BURRIS/WAGNON ARCHITECTS, P.A.

ADDENDUM NO. 1

Re: **Batson 5C Refurbishment**
University of Mississippi Medical Center
Jackson, MS
UMMC# 2026397

Life Safety Plan

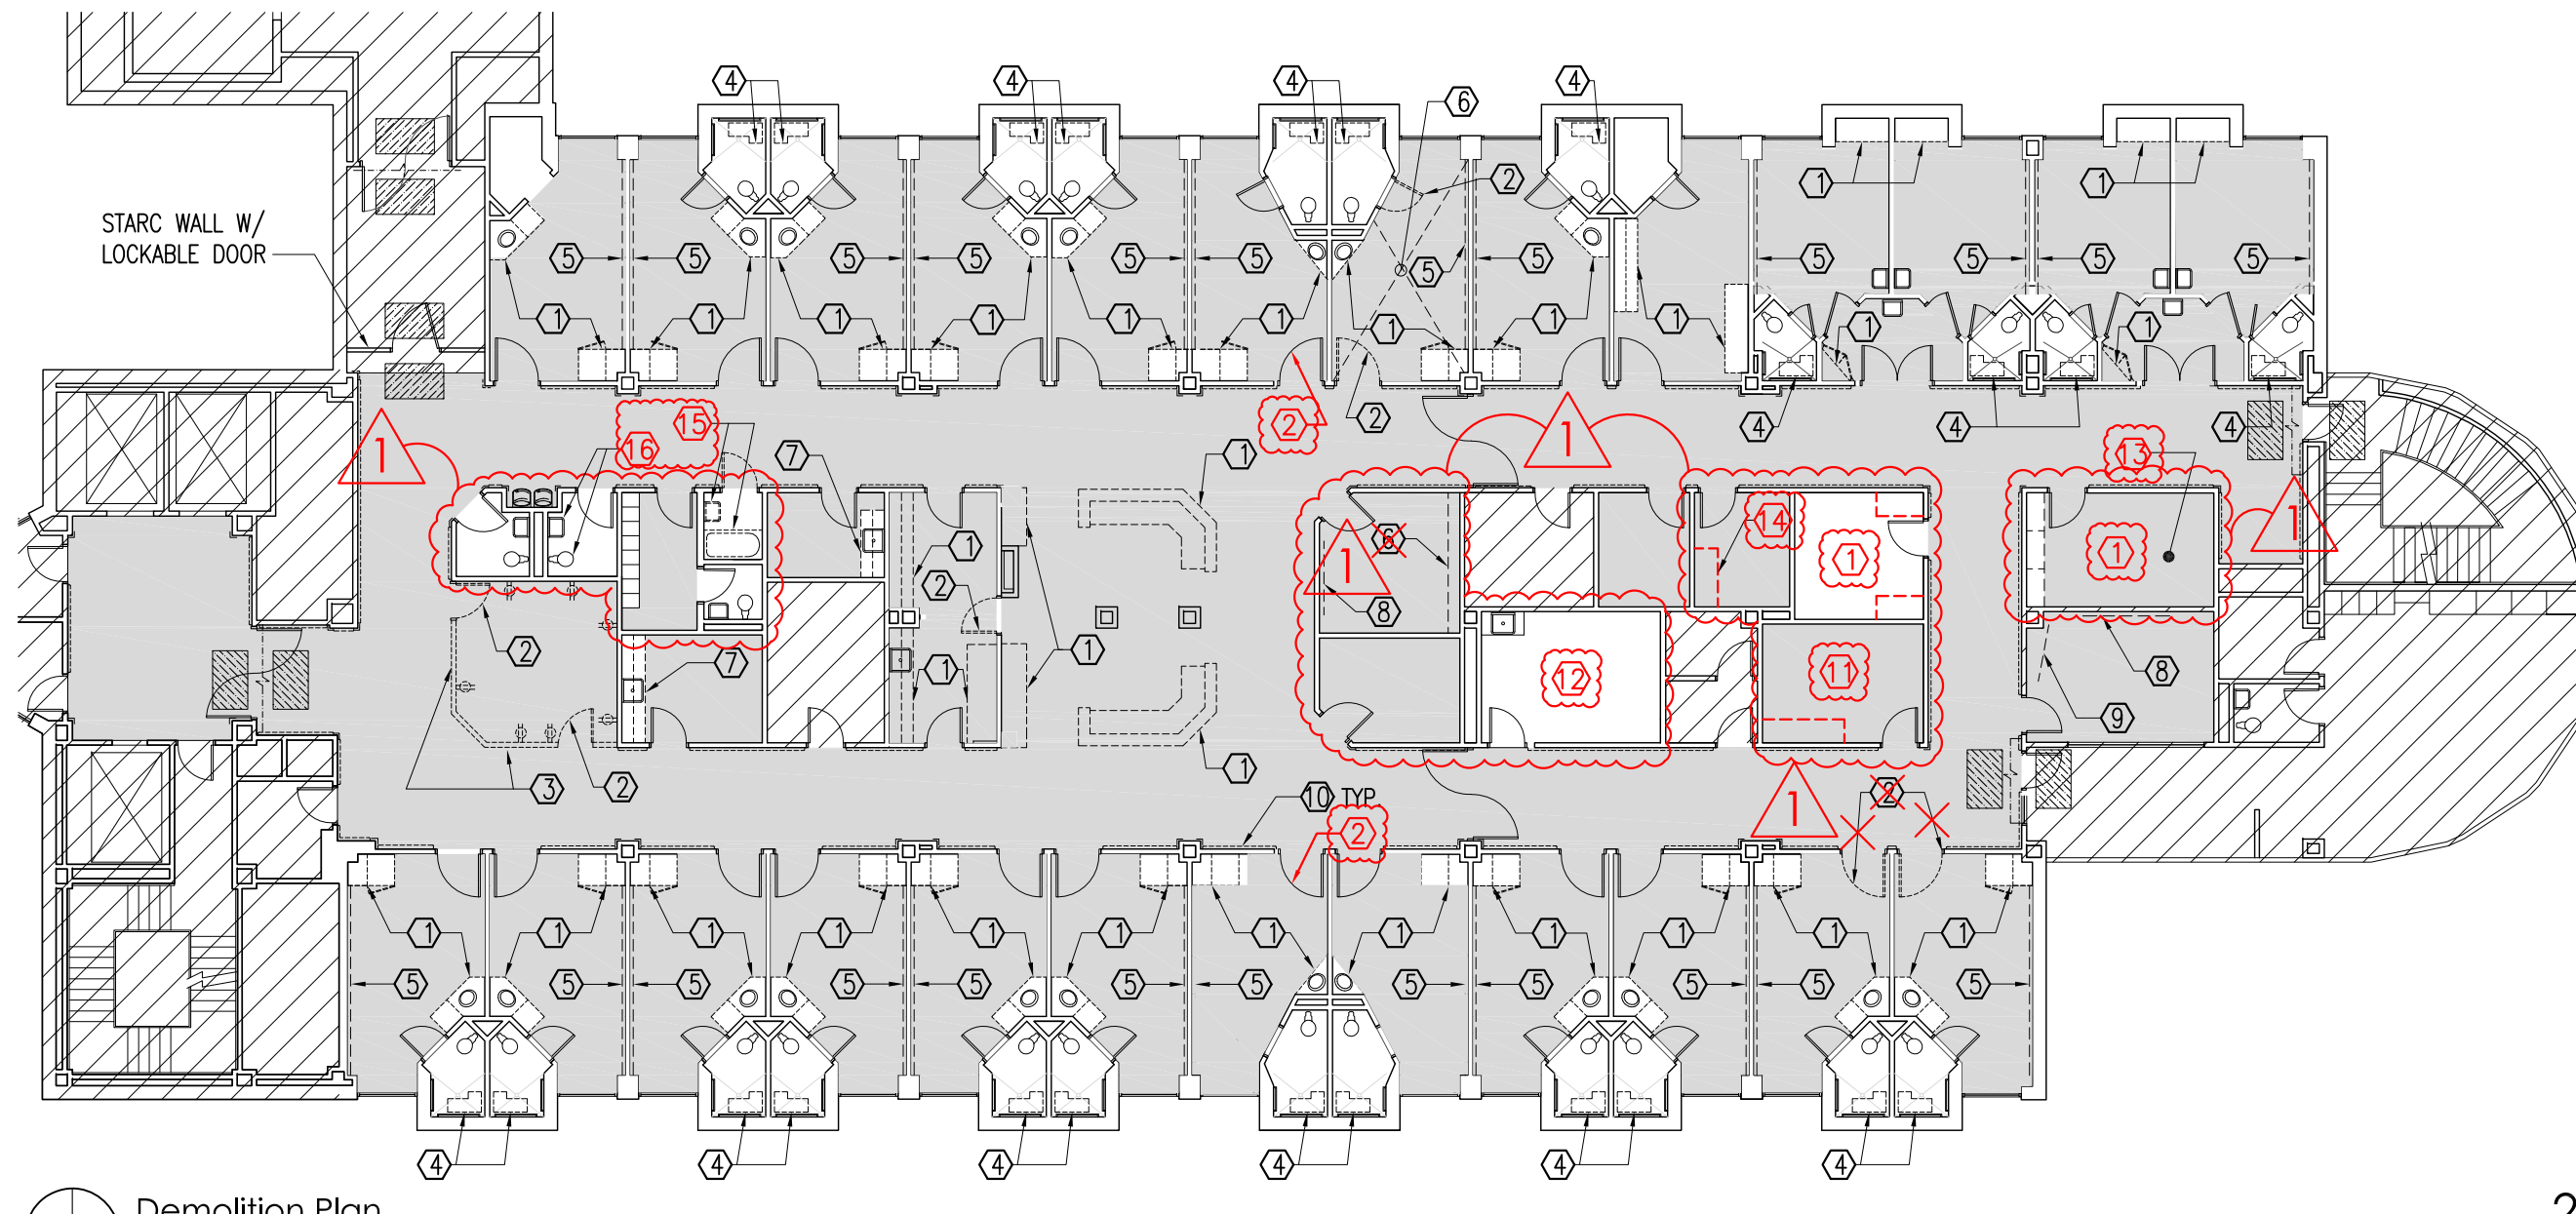
- Item No. 1: Refer to Sheet TS and add attached Life Safety Plan.
- Item No. 2: Refer to all millwork details and note that all solid surface countertops shall be mounted on two (2) layers of ¾" plywood, and bottom of plywood shall be sealed or painted.
- Item No. 3: Refer to "17/2.0" and note that top of Acrovyn impact board shall be at 4'-5" A.F.F., as shown at "16/2.0", "18/2.0", "21/2.0", etc.
- Item No. 4: Refer to Door Schedule, Sht. 5.0, door openings "12" and "32", and change the following:

BATSON - FIFTH FLOOR PLAN - HVAC
 SCALE: 1/8" = 1'-0"

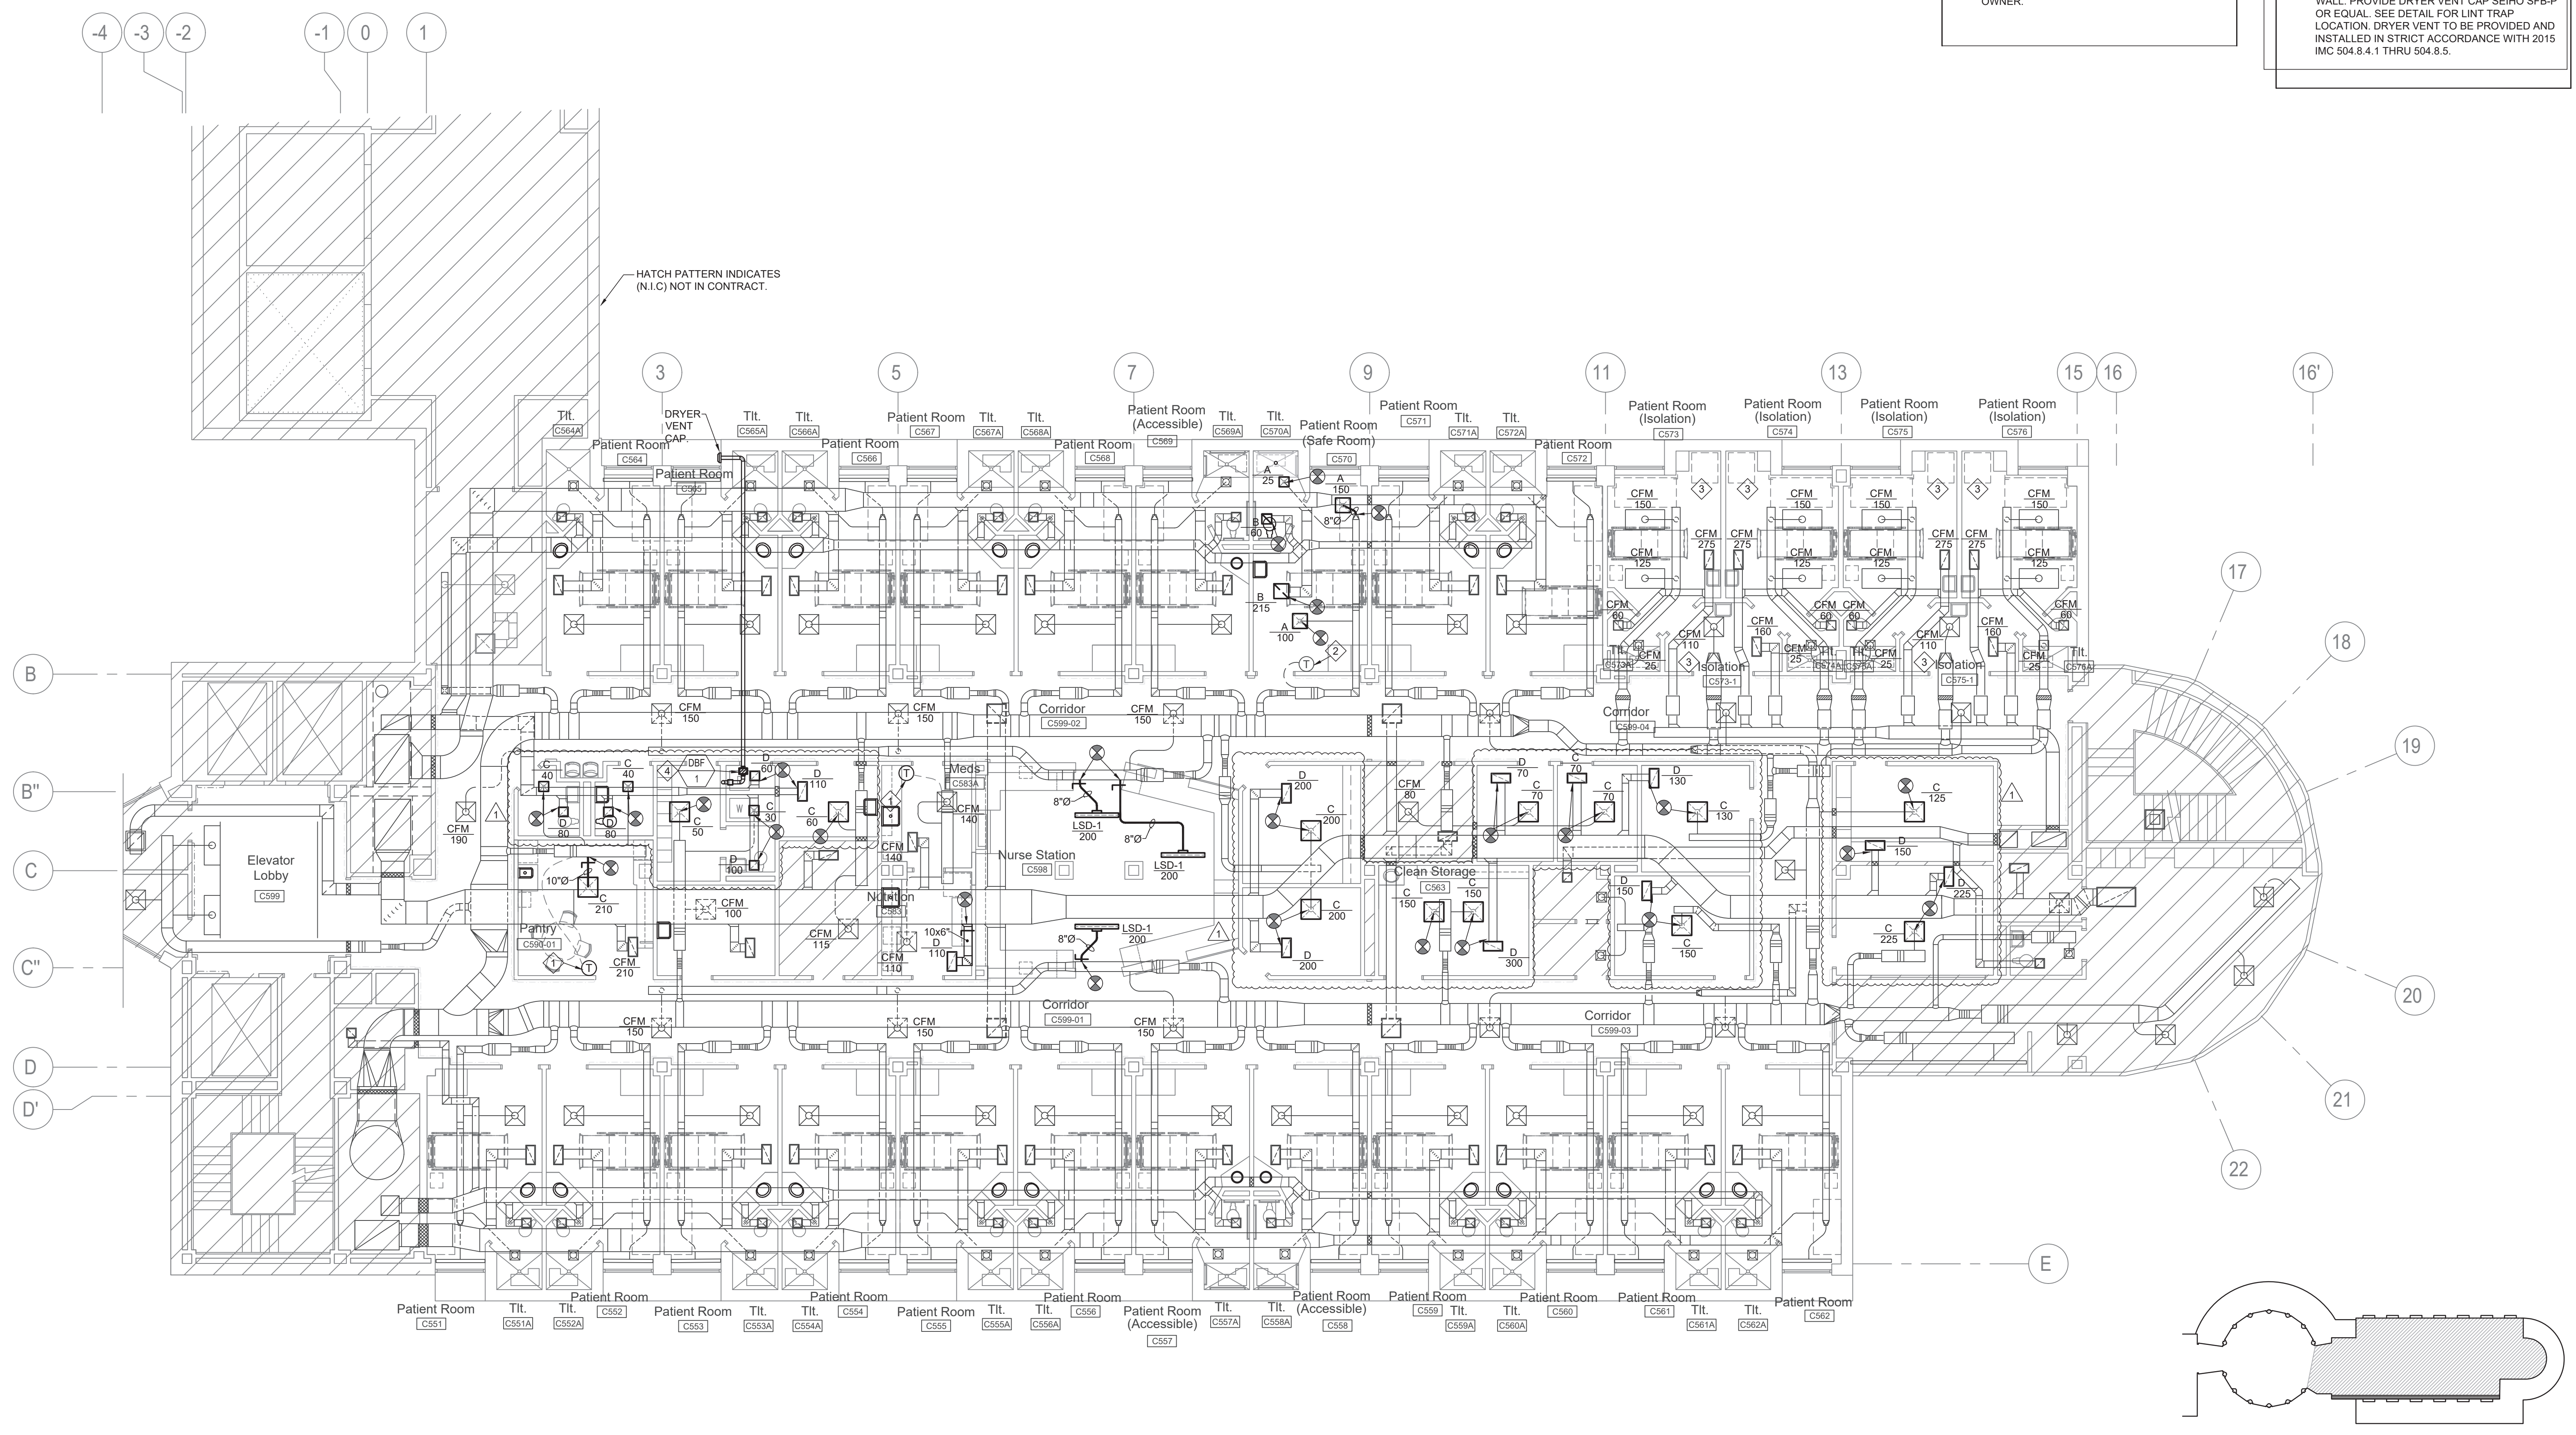
- Item No. 5: Refer to Sheets 1.0 and 3.0 and replace these sheets in their entirety with the attached annotated sheets (revisions are shown in RED).
- Item No. 6: Refer to “12/4.0” and change C370” to “C570”.
- Item No. 7: Refer to “12/5.0” and note that gooseneck faucet will not extend to the center of the drain as shown—it will stop short of the drain below, per faucet specified at mechanical.
- Item No. 8: See attached revised mechanical drawing sheets P101, P201, P501, FP201, M101, M201, M501, M601.
- Item No. 9: See attached electrical revisions, Sht. ADE202.

- IN PATIENT ROOM (SAFE ROOM) C570 SECURITY GRILLES WILL BE PROVIDED WITH A FACE OPERATED VOLUME DAMPER, SO AN ACCESS DOOR WILL NOT BE REQUIRED. IF A VOLUME DAMPER FOR THE GRILLE IS ABOVE THE CEILING, A LIGATURE RESISTANT ACCESS DOOR WILL BE REQUIRED FOR BALANCING.
- ADDITIONAL CFM SHOWN ON DRAWINGS IS FOR BALANCING ONLY.
- HVAC CONTRACTOR TO PROVIDE LABOR TO REPLACE 10 EXISTING PATIENT ROOM THERMOSTATS WITH NEW OWNER-FURNISHED THERMOSTATS, AT LOCATIONS DIRECTED BY OWNER.
